Seven Sisters Market – Supply recommendations

2. Sub Main DBs - Rectification proposal – All sub main cables to remain

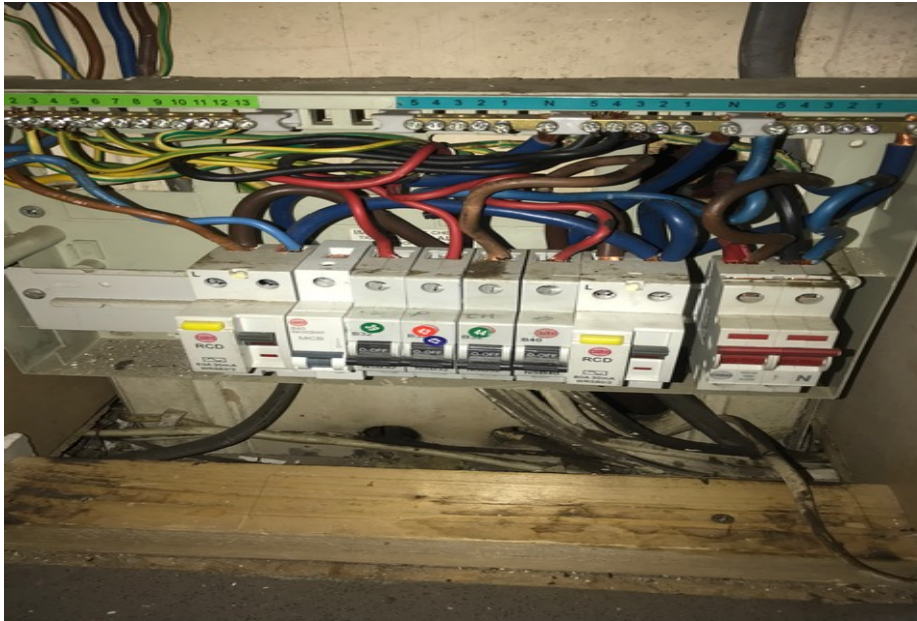
The existing three phase, 3-way fuse board does not have enough capacity to supply the 15 sub boards located within the market. The existing main fuses each have two supplies connected causing overloading. The fuse board also has damaged components and exposed live conductive parts.

Items marked red to be removed and new MCCB Distribution panel installed

- Remove existing MEM 3-way fuse board
- Remove existing fuse switches
- Remove existing trunking
- Install new 3 phase 12-way MCCB distribution panel
- Install new trunking
- Tidy existing SWA cables on new cable tray
- Re-locate and arrange earth bar
- Install Labels
- Test and commission

1L1 – DB1 – Units 44,37,38,43, (3)

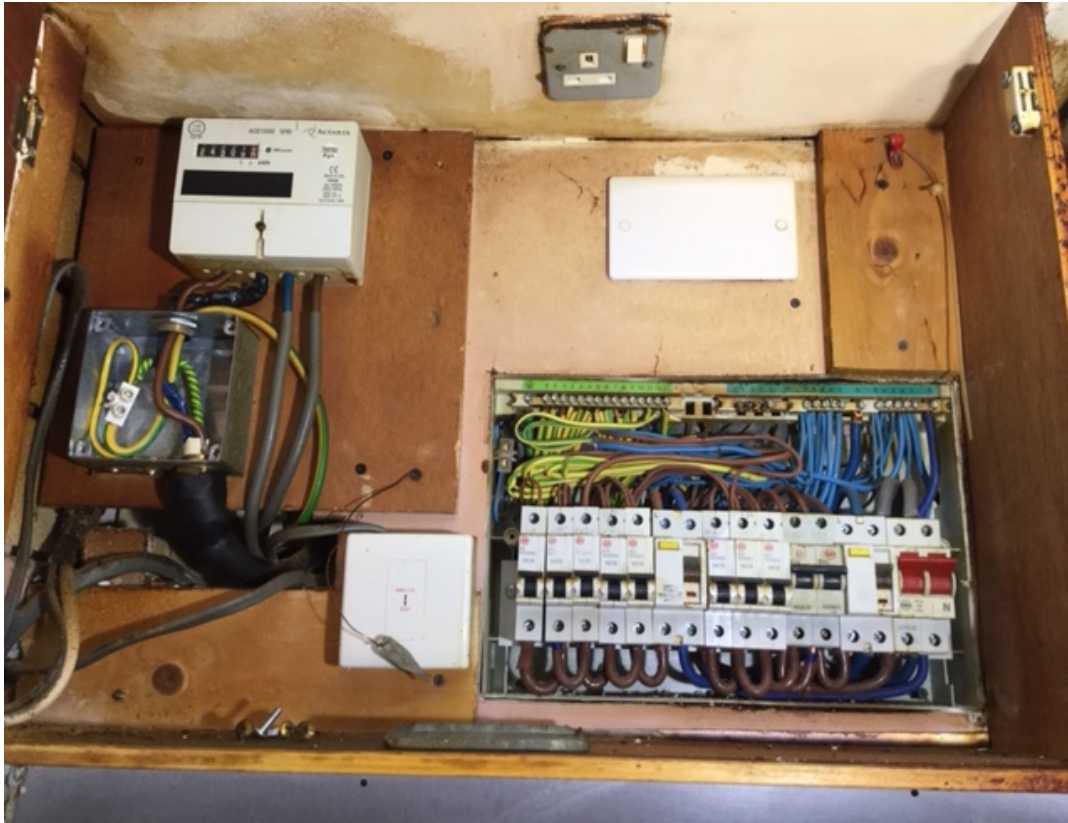
There is not enough capacity for existing circuits, new DB is required.

- Existing sub main cable to remain
- Remove existing DB
- Re-locate supply to unit 3 to DB1
- Install with new 8-way DB with MCBs
- Install entry stuffing glands for incoming cables to DB
- Install labels
- Test and commission

1L2 – DB2-units 36&29

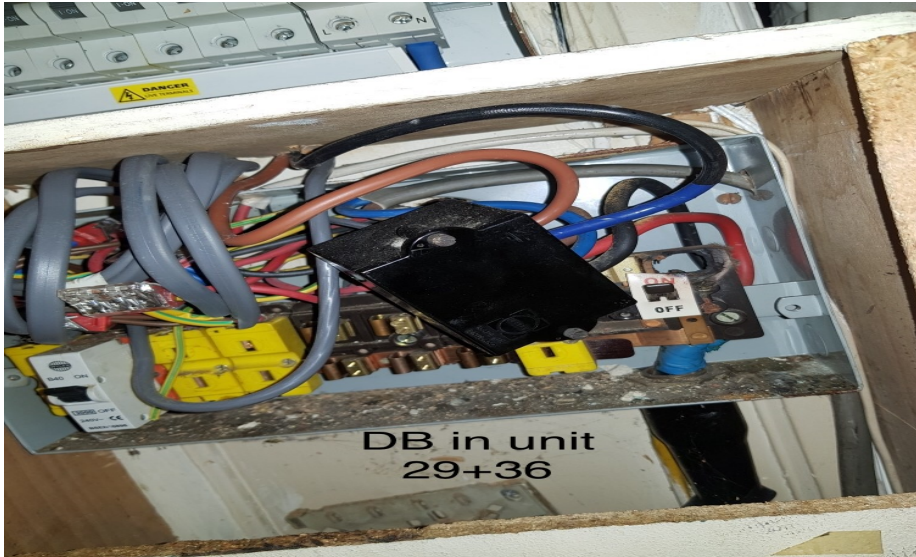
Bus bar missing, mixed manufacturer MCBs and evidence of burning. Adaptable box not joined correctly with single core cables entering meter.

- Sub Main cable to remain
- Remove existing DB
- Install fixed base connectors and DI tails to meter
- Install new 10-way split RCD board
- Install labels
- Test and commission

1L3 – DB3 – units 30,35,31,32,33,34

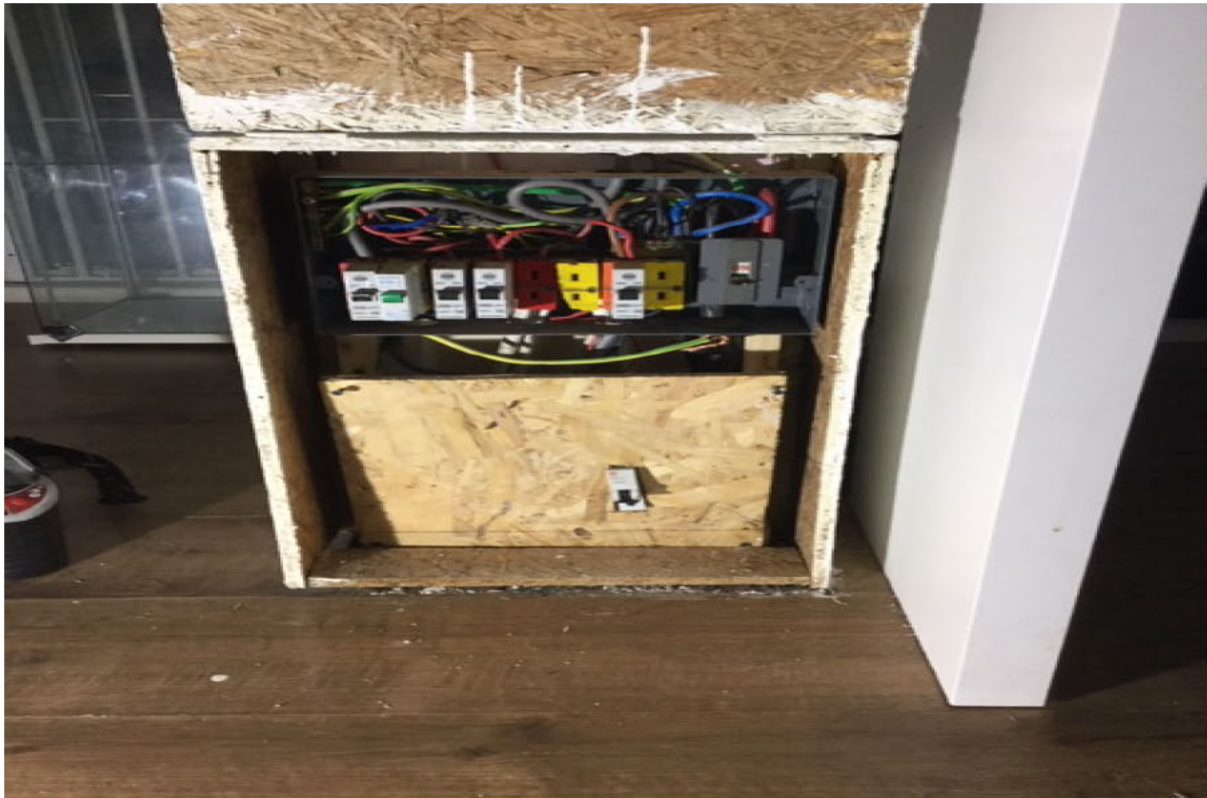
Distribution board used as joint boxes, mixed manufacturers MCBs, broken with exposed conductor parts

- Sub Main cable to remain
- Remove existing joint boxes and exposed parts
- Install new single phase 8-way MCB board with 6 x 32A MCBs
- Entry stuffing glands
- Install labels
- Test and commission

2L2 – DB5 units 13,14,15,16,17,18,19,20

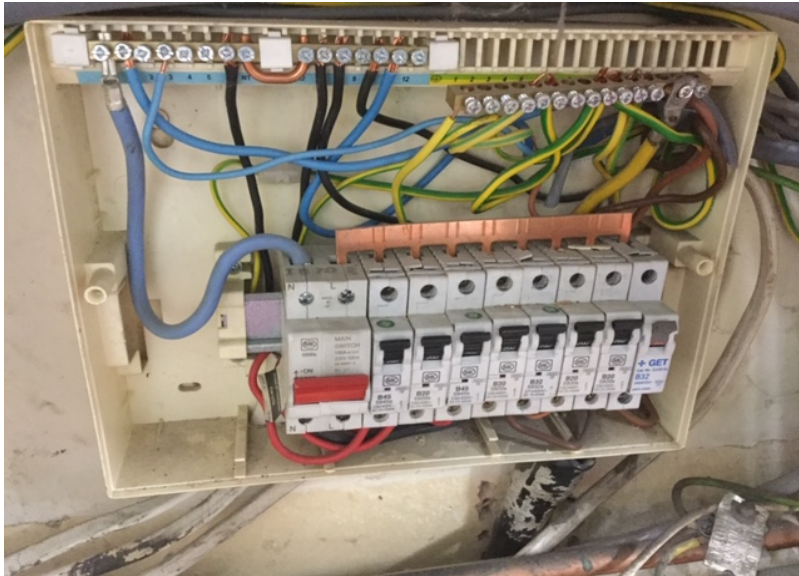
Arrangement of MCBs incorrect. IP4X not achieved. These units have been suggested to be rewired, a new DB would be recommended to remove existing sub boards within units.

- Existing SWA sub main to remain
- Remove existing DB
- Install new metal DB
- Entry stuffing glands
- Labels
- Test and commission

2L3 – DB6 – units 56,57,58,59a,59b

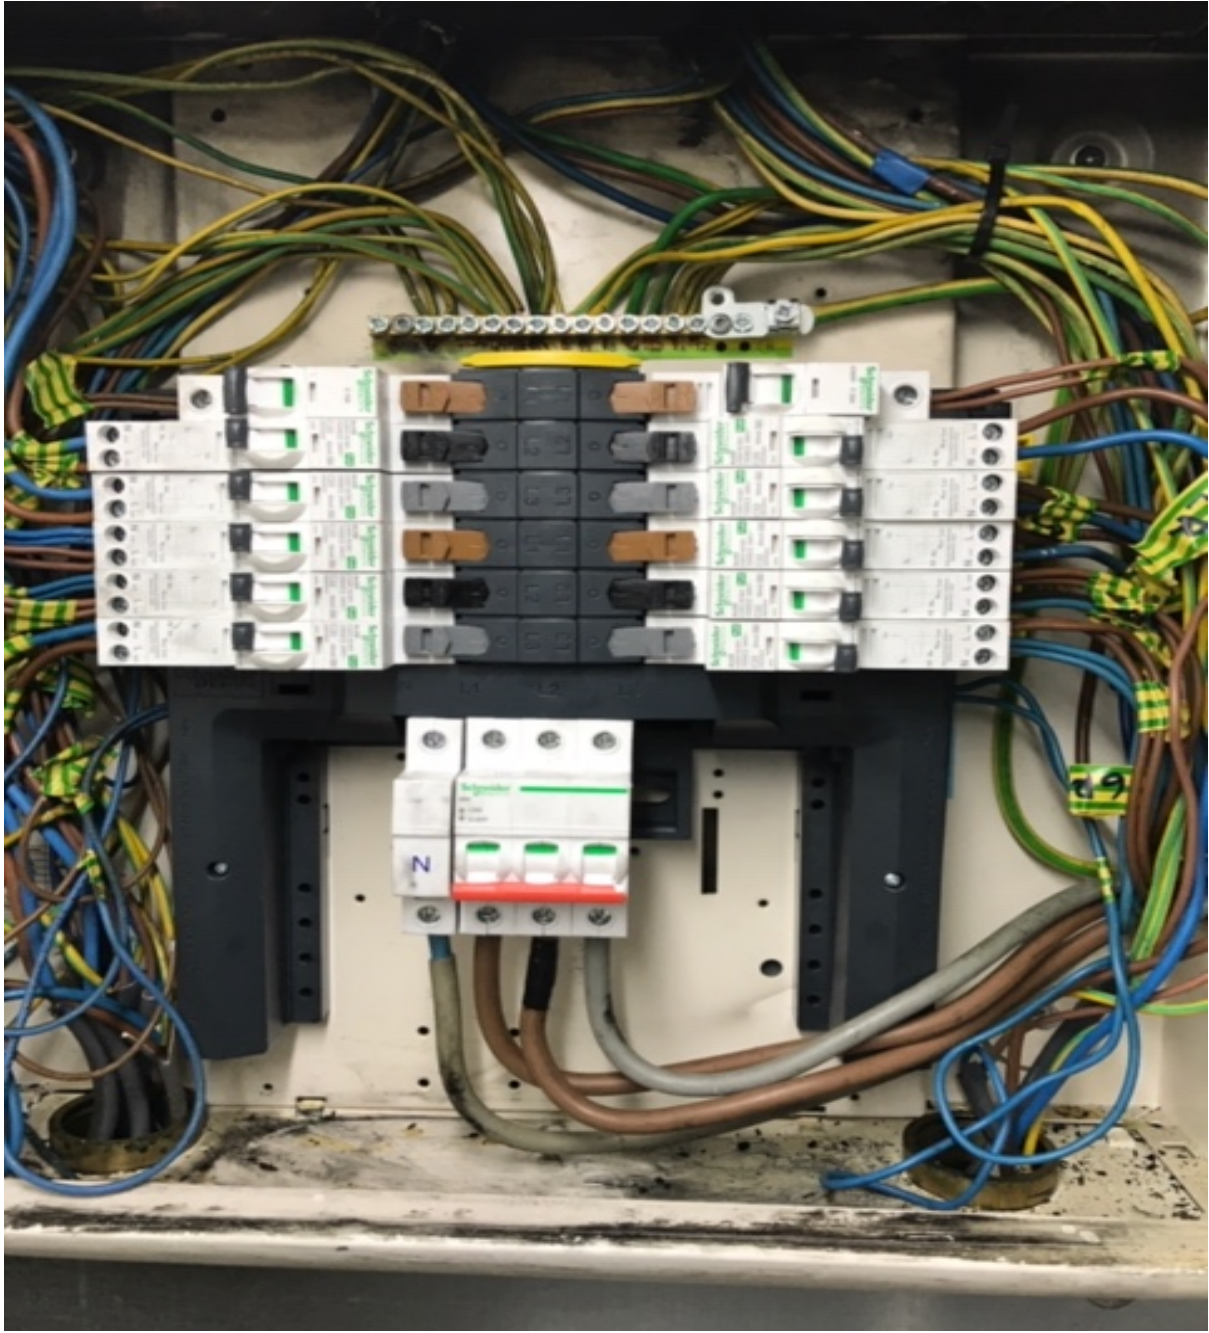
Bus bar installed incorrectly and mixed manufacturers MCBs.

- Existing sub main cable to remain
- Remove DB
- Install new DB
- Install new labels
- Test and commission

4L1 – DB8 – units, 3,7,8,9, communal lighting, and power

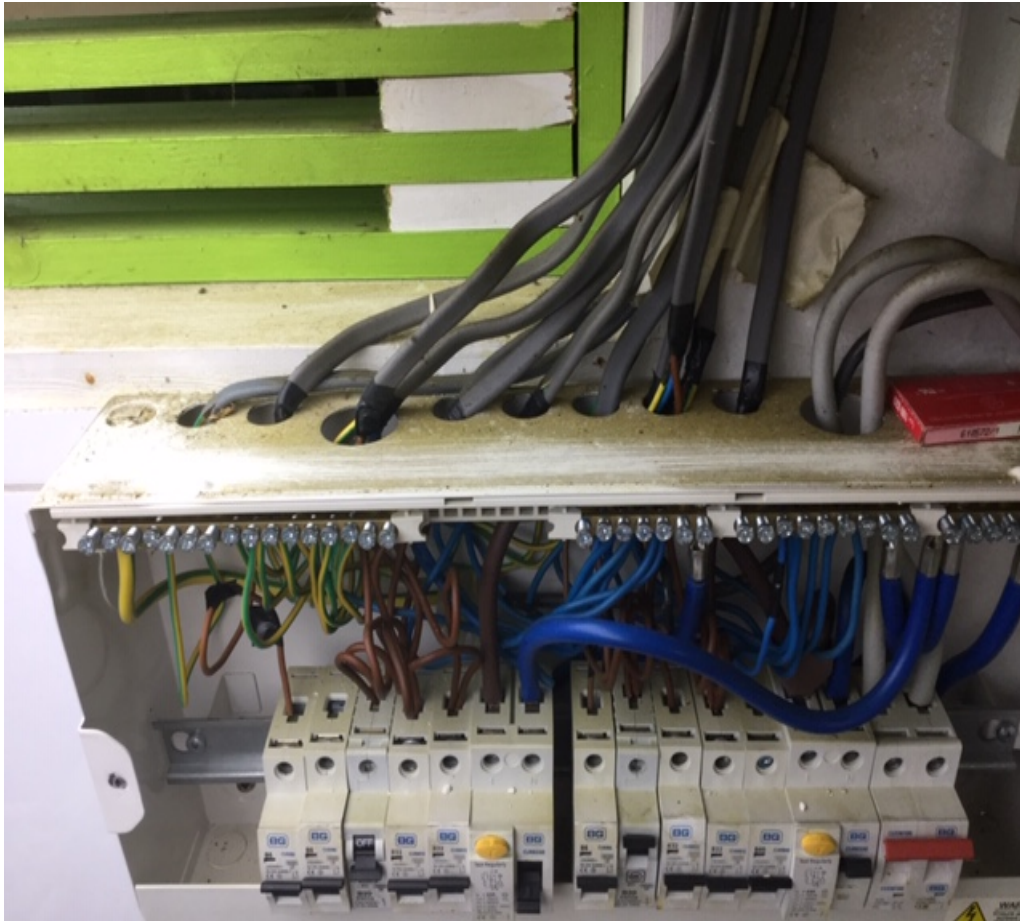
DB contains MCBs from mixed manufacturers. Holes in DB

- Existing S WA sub main to remain
- Remove existing DB
- Install new metal DB
- Entry stuffing glands
- Labels
- Test and commission

5L1/2/3 – DB11 – unit 52,53

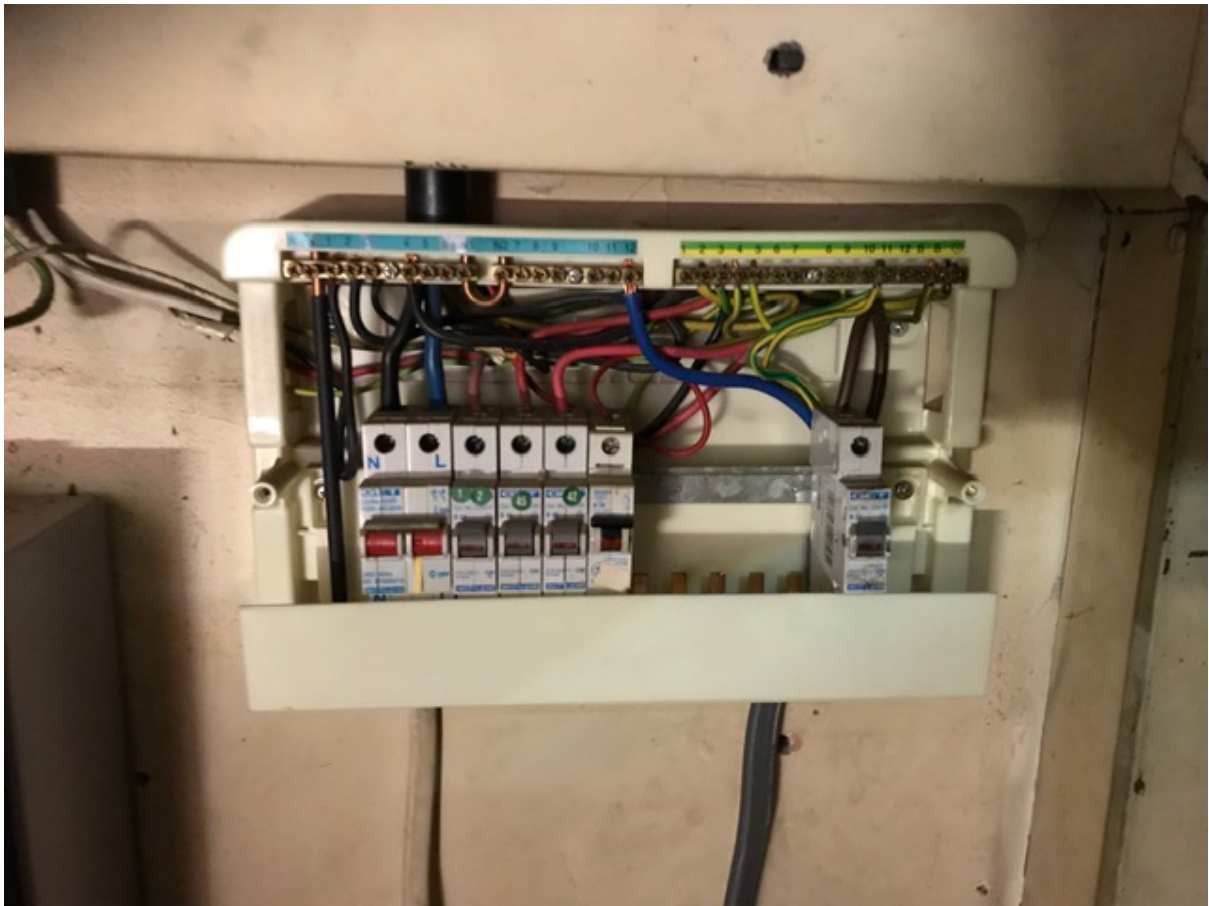
DB damaged with exposed conductive parts and obsolete.

- Existing single core cables supplying board to remain
- Remove existing DB
- Install new three phase metal MCB board
- Entry stuffing glands
- Labels
- Test and commission
-

6L1 – DB12 – units,1,2,45,46,39

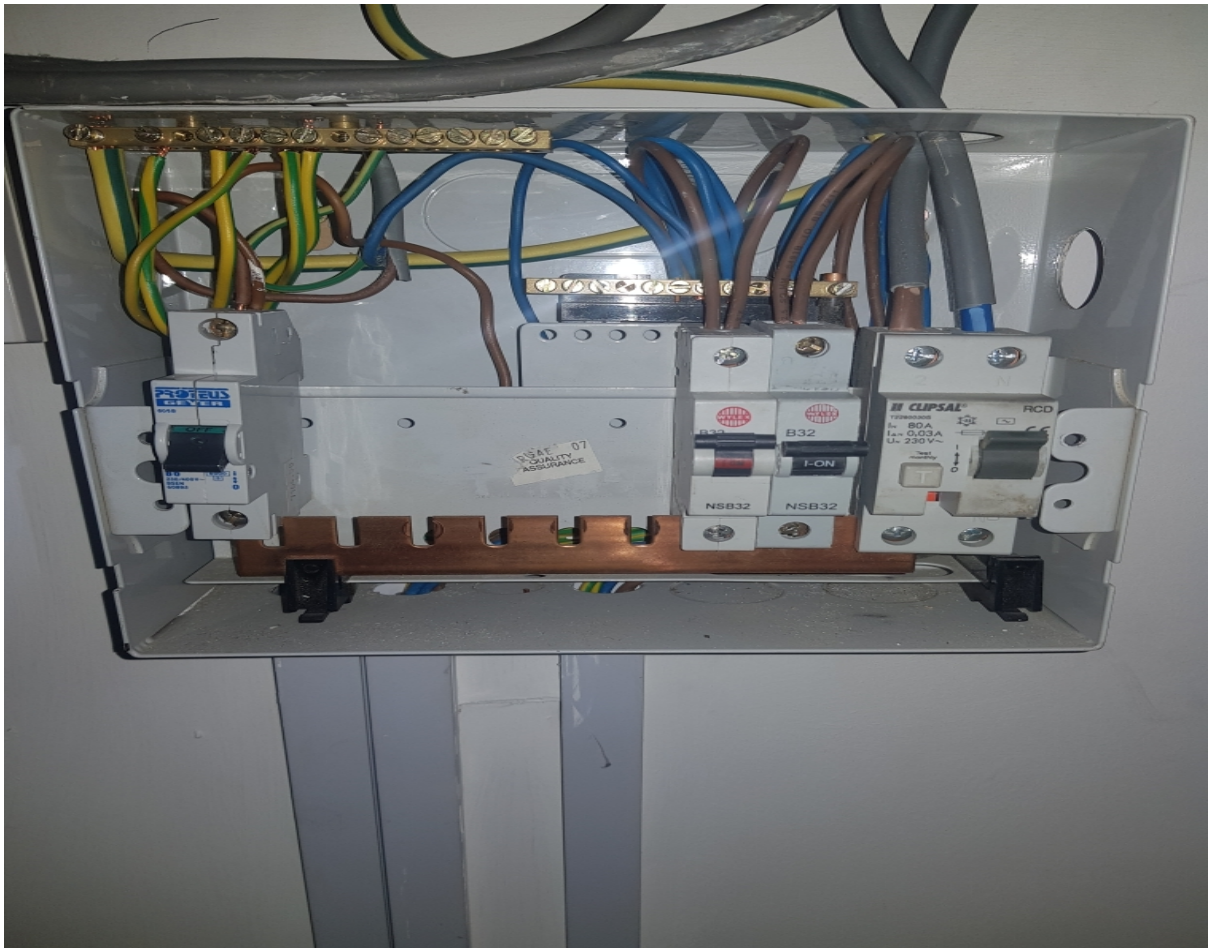
DB contains mixed manufacturers MCBs. Existing DB is damaged. DB is obsolete. Re-wire the configuration

- Remove existing single core cables run on tray supplying DB
- Install new sub main SWA cable
- Remove existing DB
- Install new metal DB
- Entry stuffing glands
- Labels
- Test and commission

DB 14 – 6L3

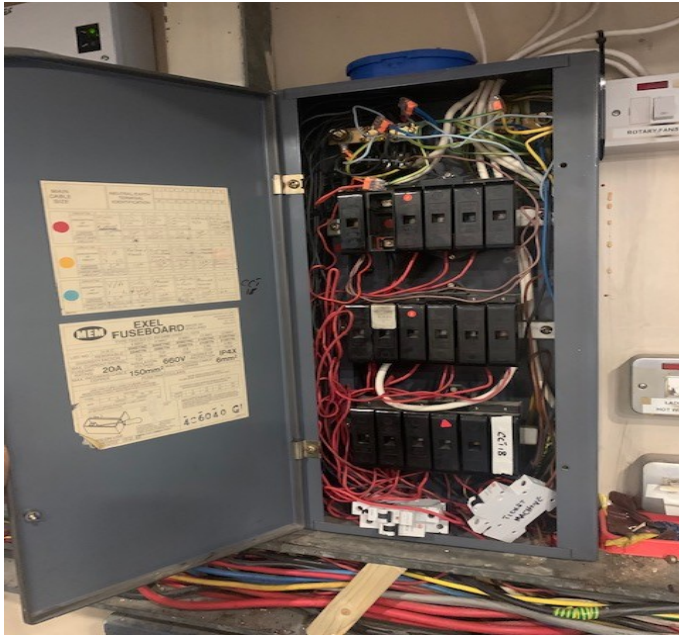
Distribution Board satisfactory no requirement to replace
Sub Main cable also to reman
